Product Change Notification

Product Change Notification: PCN-23-174020 **PCN Date:** 08-MAY-23

General Product Description:
DEUTSCH DT12-L012-GKT Foam Gasket

Current gasket 	Future gasket 
One piece housing fitting (new connector) 	Welded flange fitting (old connector)

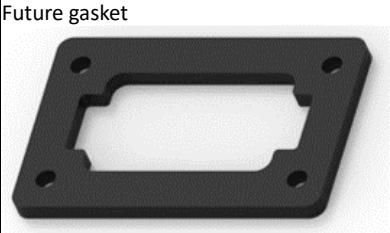
The Industrial and Commercial Transportation business unit of TE Connectivity is changing the internal geometry of the gasket for the part number listed below. These PNs are TE proprietary designs, therefore considered catalog/general market product. PPAP and/or sample requests must be submitted within 14 days of PCN submission via ict-ppap-request@te.com or ePPAP system. Submission will not occur without request. If PPAP requested, disposition response is required within 14 days of submit date or it will be considered approved. Product drawing(s) is affected.

Reason for Changes:
Dear Customer, we hereby inform you of this change. The change is necessary to allow the gasket to fit the new geometry of DT04-12PX-XXXX one piece design per PCN-22-147467-. The change does not impact performance. IMPORTANT: The current and previous revisions of these parts cannot be used interchangeably with the DT04-12PX-XXXX one piece design. The change(s) are being phased in gradually and previous revision cannot remain stocked until use. Shipments of both configurations may not be mixed.
